**Re: Flatiron Meadows Planning Area C Preliminary Plat, Amendment No. 2
Comment Response Letter**

**FLATIRON MEADOWS – PLANNING AREA C
PRELIMINARY PLAT REVIEW RESPONSE**

FLATIRON MEADOWS PRELIMINARY PLAT, AMENDMENT NO. 2

EXISTING LAND USE MAP

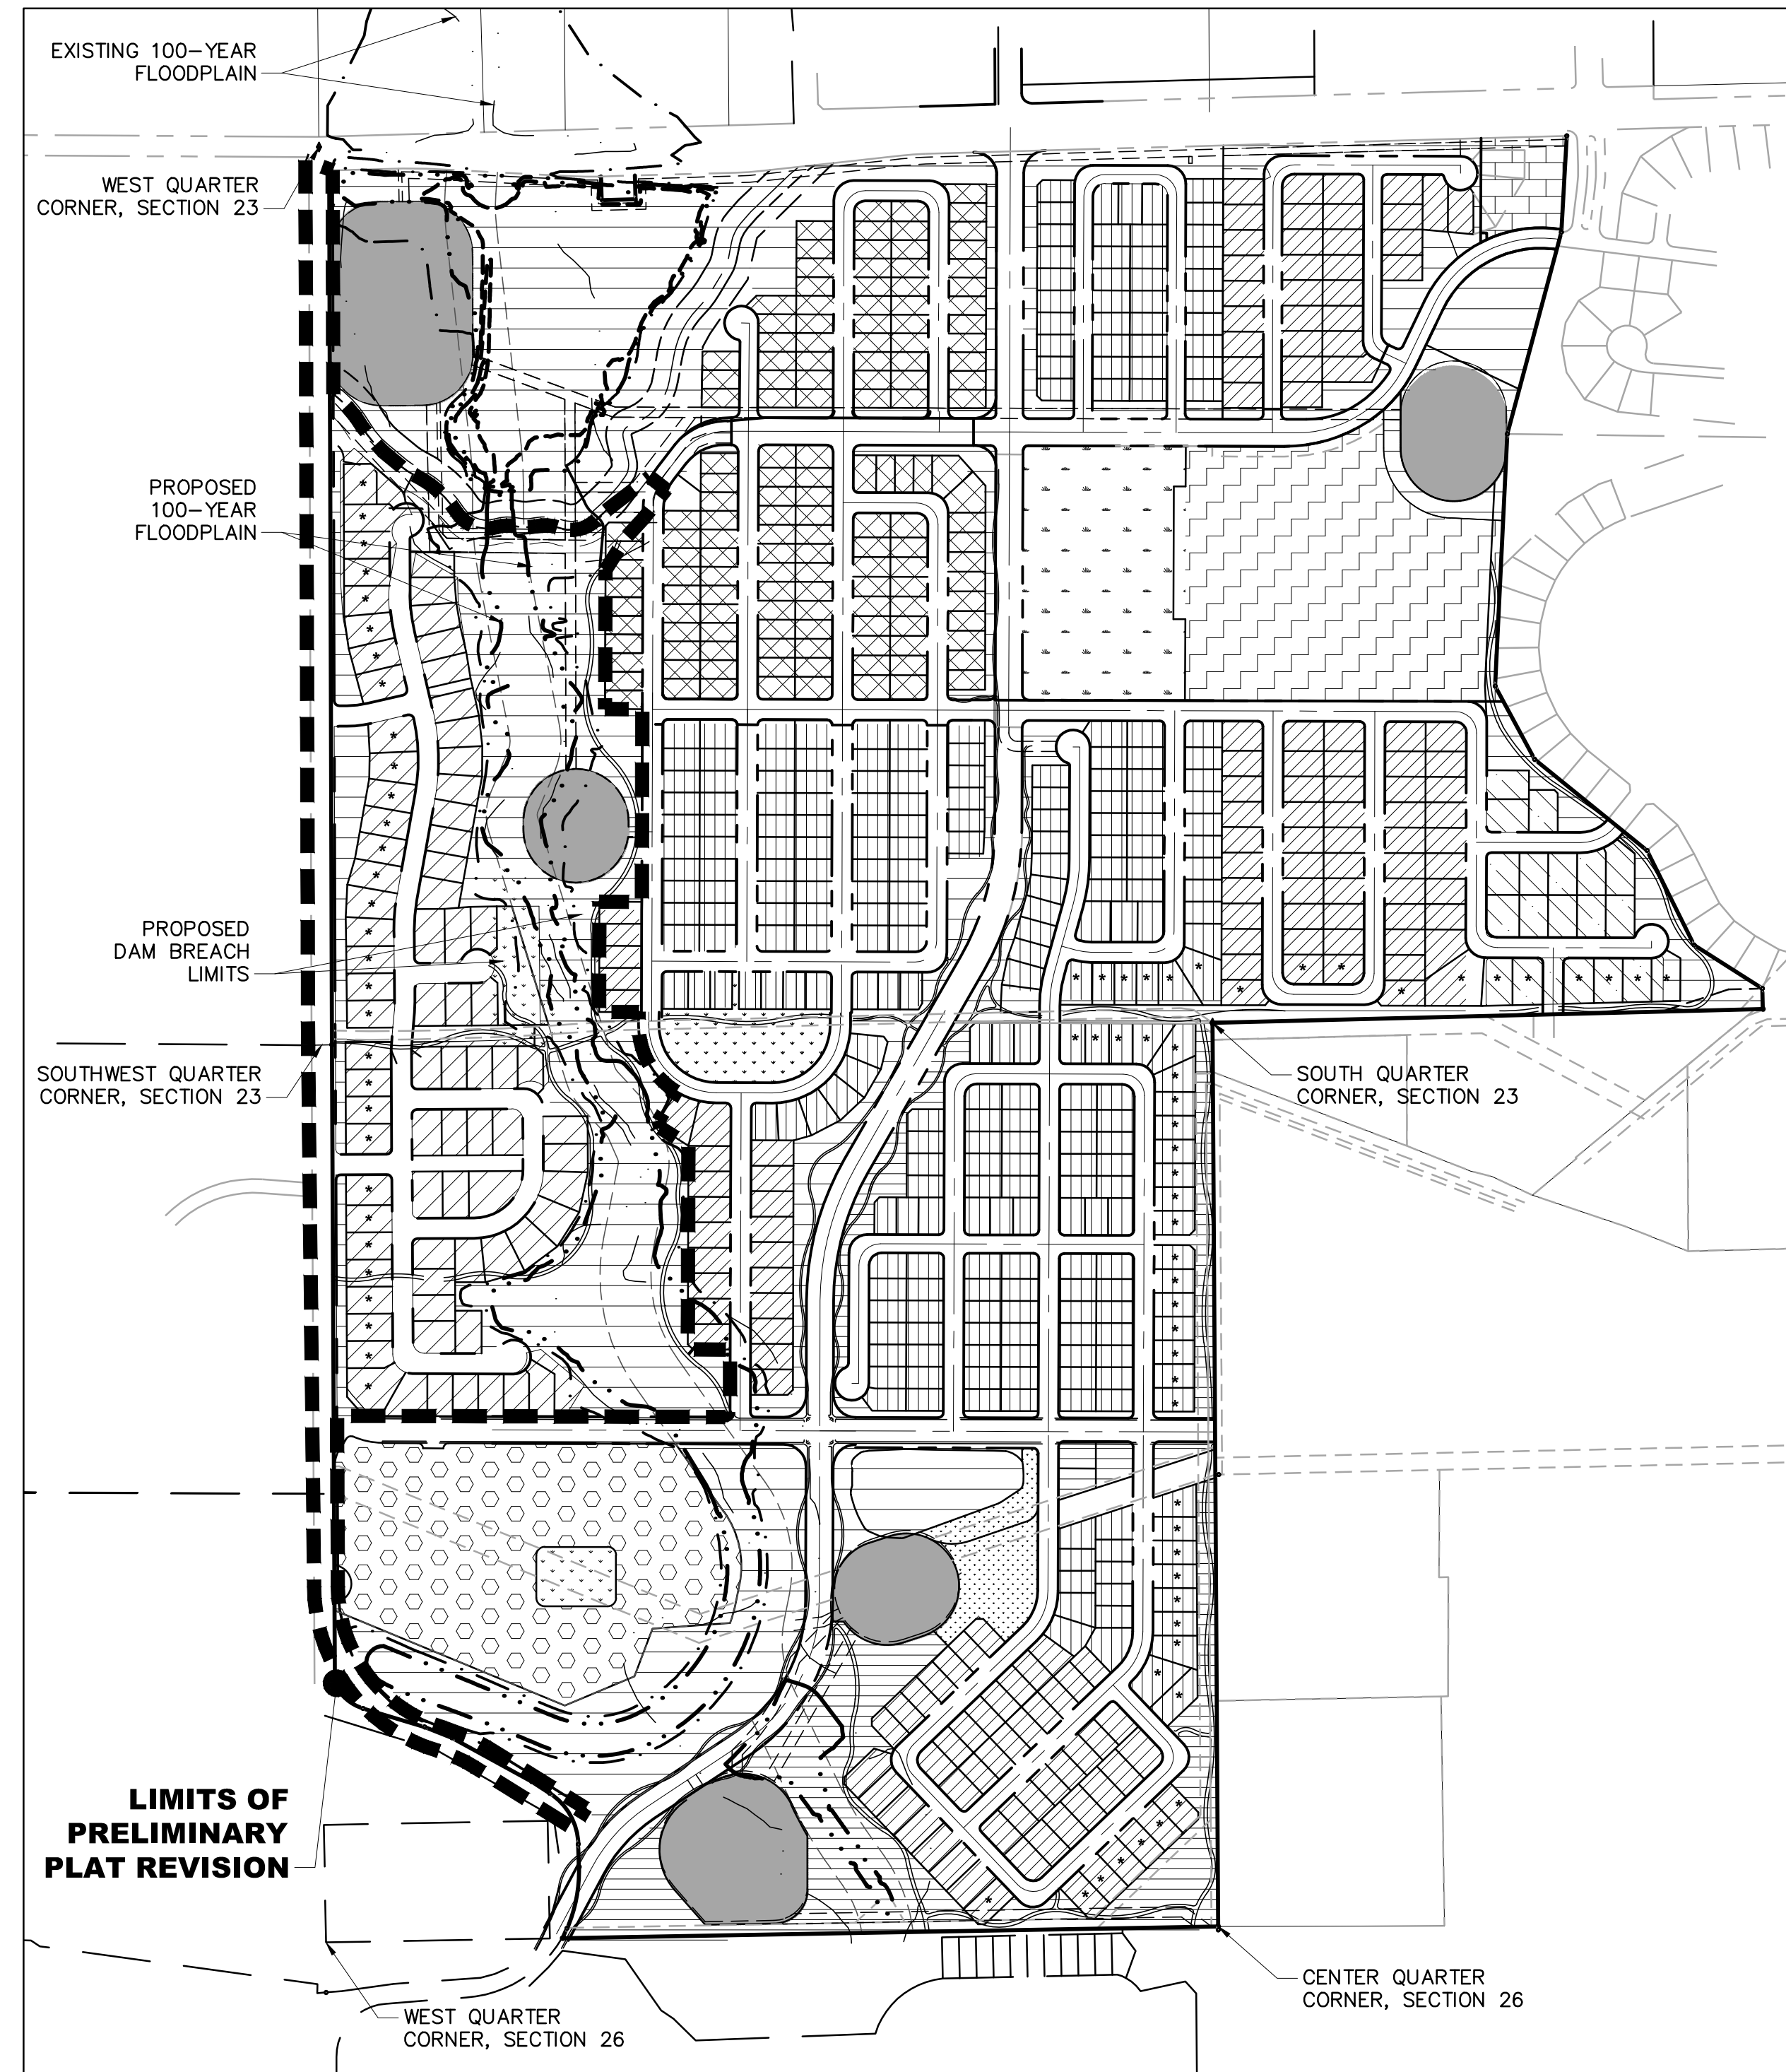
Response: The open space summary chart has been updated and moved to sheet 6.
3. Sheet LU1 – Land Use
 - a. The Existing Land Use Map does not match the approved Preliminary Plat, Amendment No. 1. The multi-family and pocket park hatch at the southwest corner of Erie Parkway and Flatiron Meadows Boulevard is still shown.

Response: The Existing Land Use Map has been modified to reflect the approved Preliminary Plat, Amendment No. 1.
 - b. As 111th Street is a part of this amendment, the dashed line extents of the plat amendment are properly shown in the Proposed Land Use Map. Please revise the limits to match in the Existing Land Use Map.

Response: The limits of the Existing Land Use Map have been revised to show 111th Street.
4. Sheet PH1 – Phasing Plan
 - a. Some lots are missing number labels. Please add.

FLATIRON MEADOWS
 PRELIMINARY PLAT
TRAIL PLAN

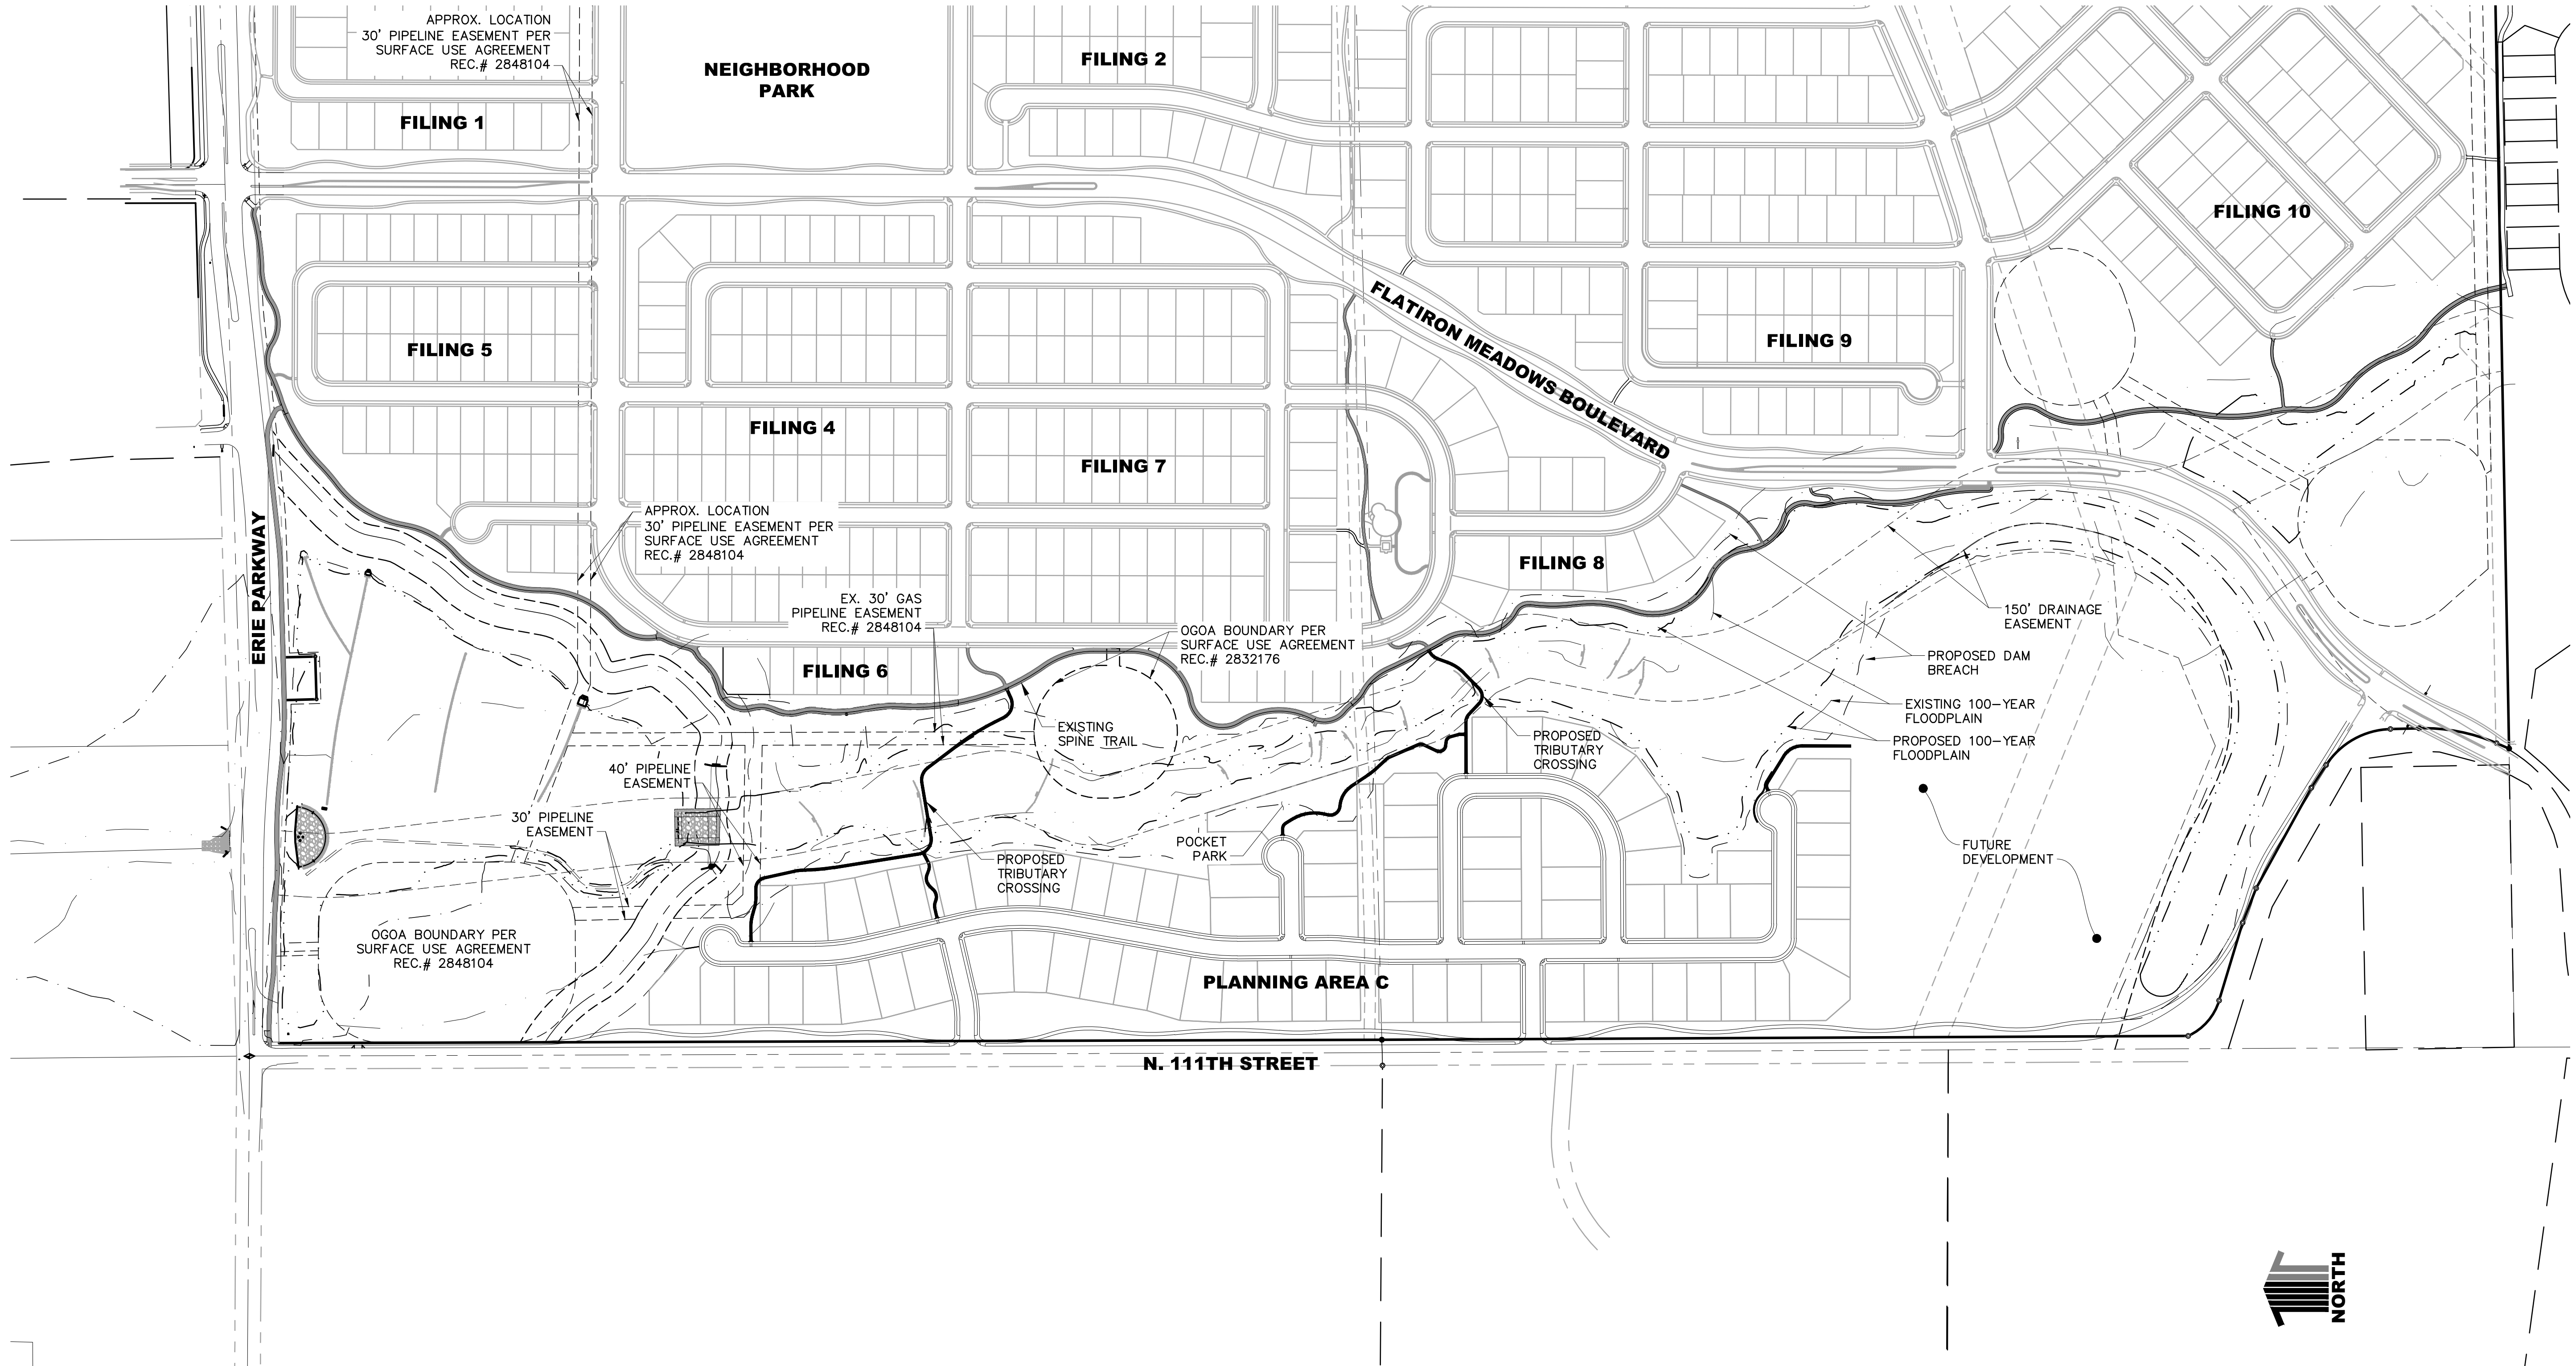
Response: This has been corrected.
5. Sheet TR1 – Trail Plan
 - a. Trails are not shown at all through-block connections and ends of all cul-de-sacs. Some connections may be limited by grading restraints. While a trail along the back sides of lots west of the tributary may not be feasible, some rear of lot connections can be made. See redlines and add connections.

Response: Requested trail connections have been added.
 - b. Move the north tributary crossing further to the north. This will limit the amount of time that local trail users are on the regional spine trail.

Response: This tributary crossing hasn't been moved north due to safety concerns with a crossing at the drop structure. The crossing to the south is coordinated with the grade control structure and aligned with the sidewalk on the south side of Front Range Lane.

FLATIRON MEADOWS
 PRELIMINARY PLAT
OPEN SPACE PLAN

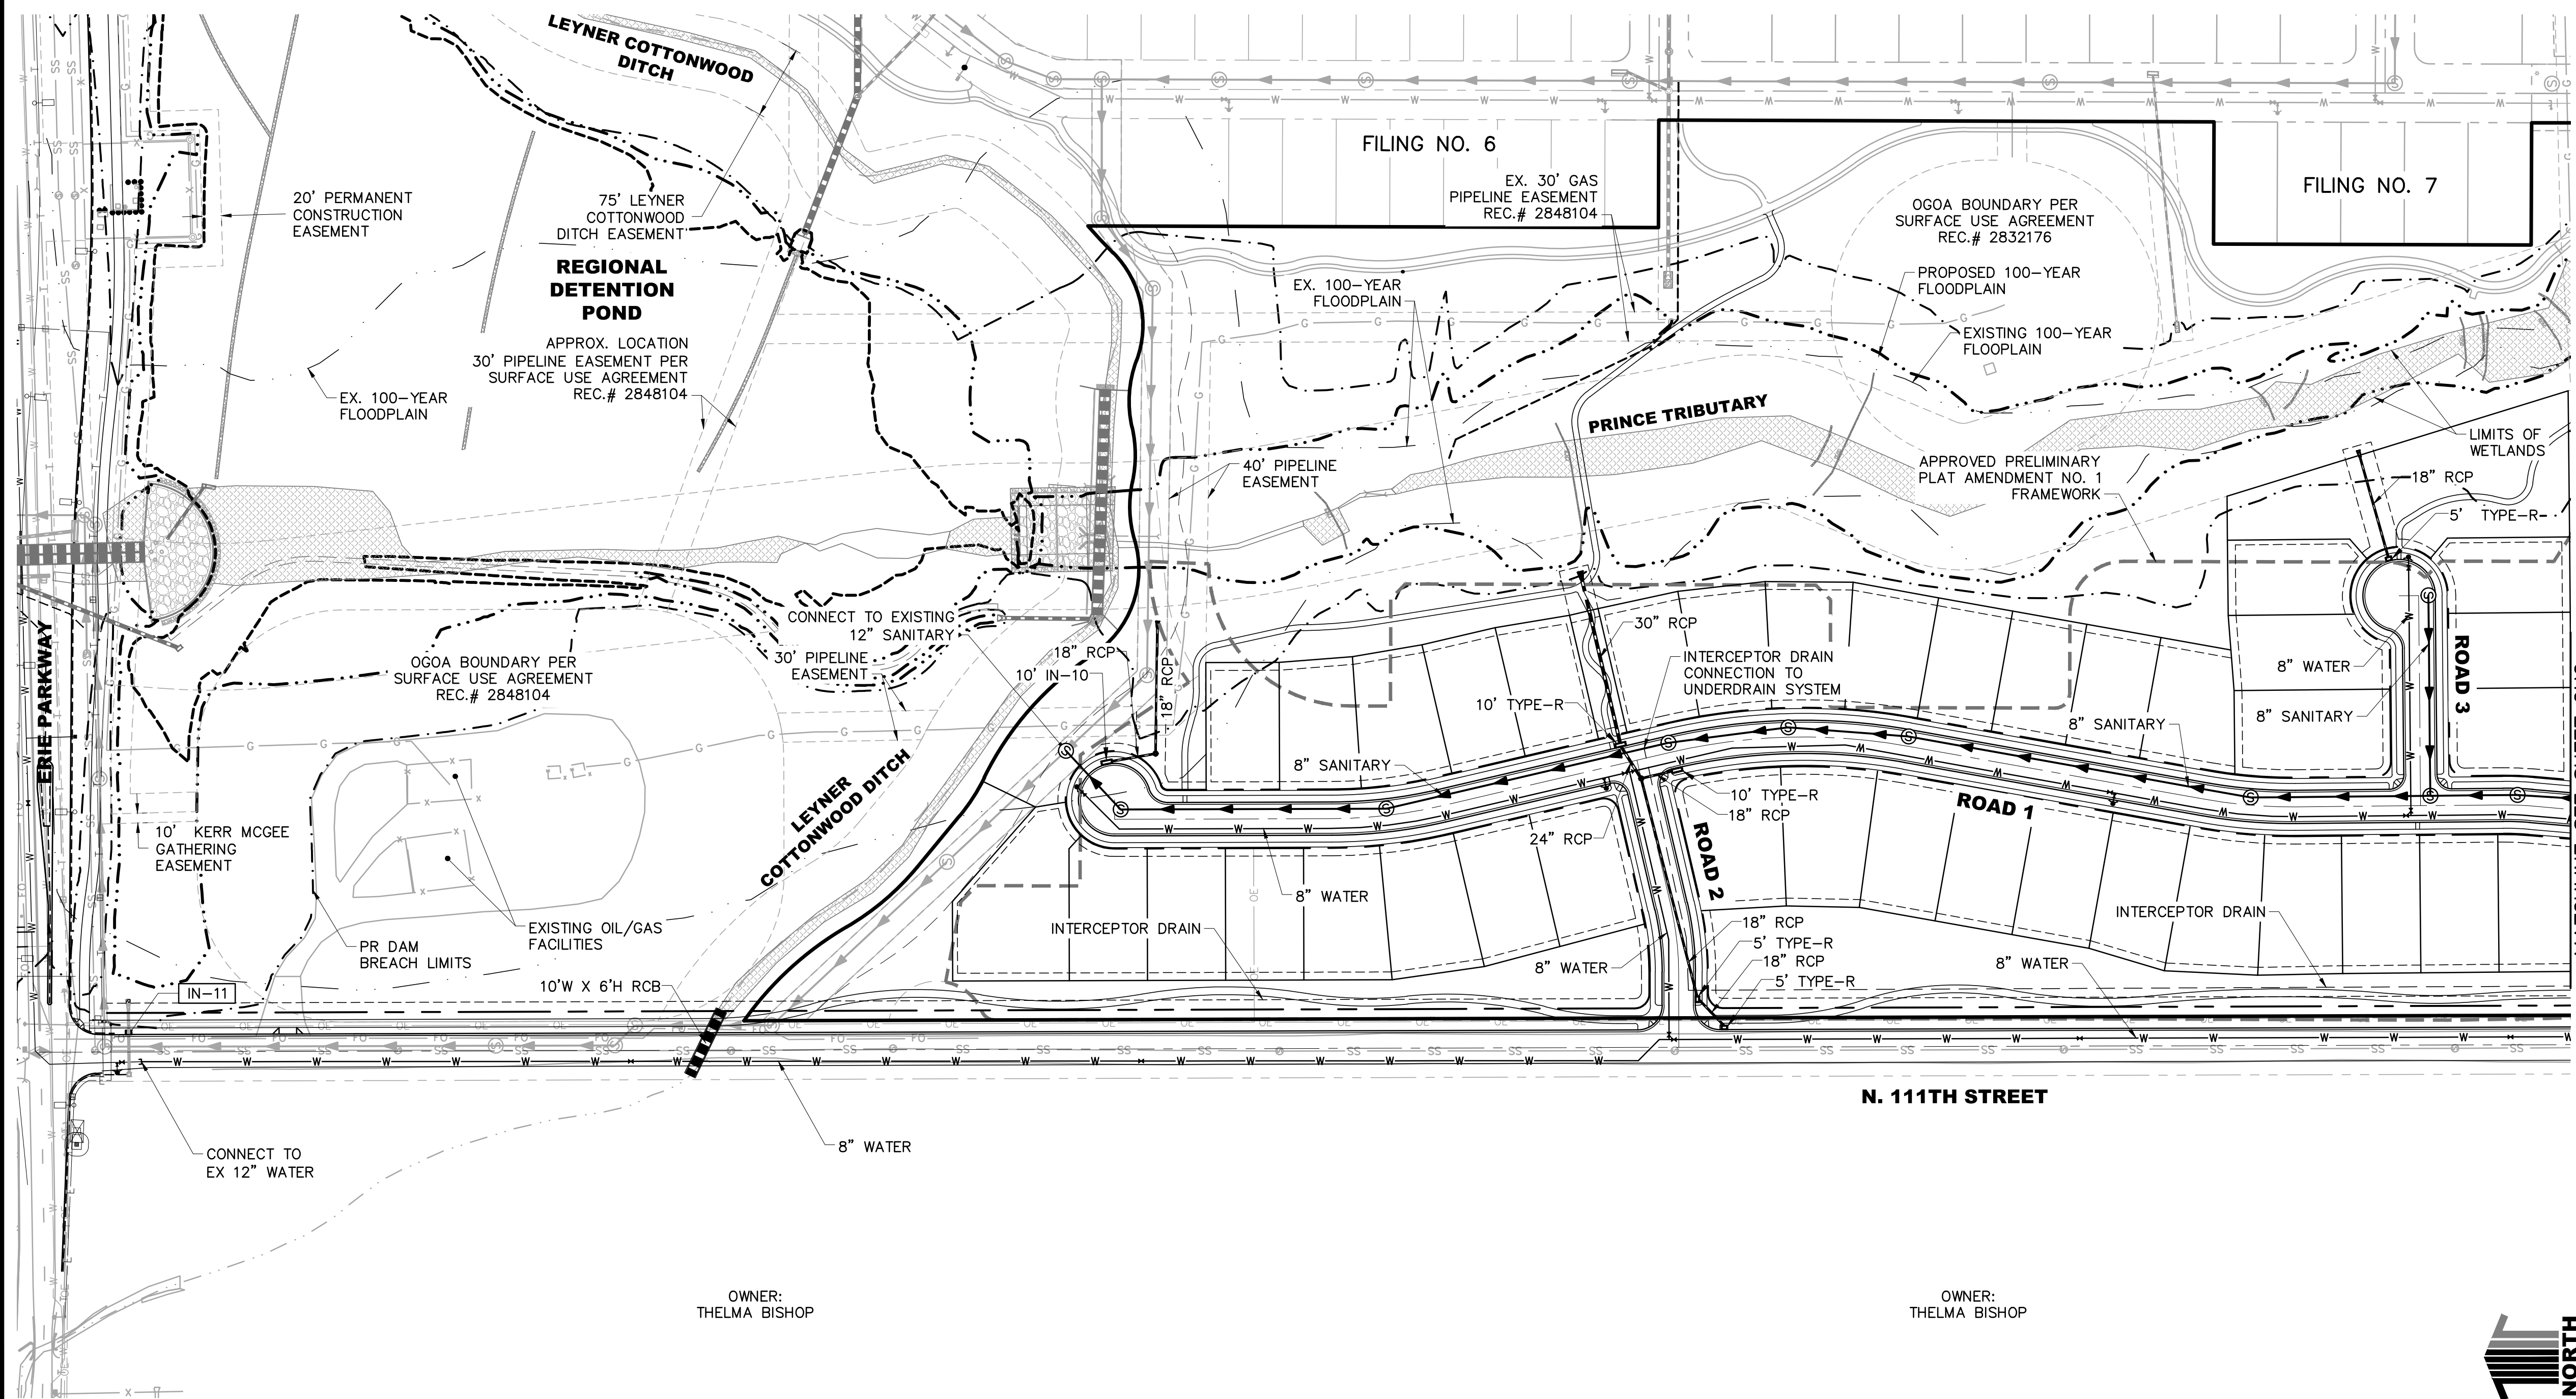
Response: Backgrounds for adjacent filings have been updated in the plans.
 - c. Provide an exhibit detailing the open space areas that qualify for the Town's dedication requirements. Show a bold outline around the open space tracts. Within the tracts, provide different hatches for portions of the tract that don't qualify as open space (i.e. O&G setbacks, slopes exceeding 5:1, detention greater than 5' in depth, etc.) versus portions of the tracts that do qualify.

Response: An Open Space Plan has been added to the plat. Please see sheet 6 for details.
 - d. See redlines for reference, additional comments, and technical corrections.
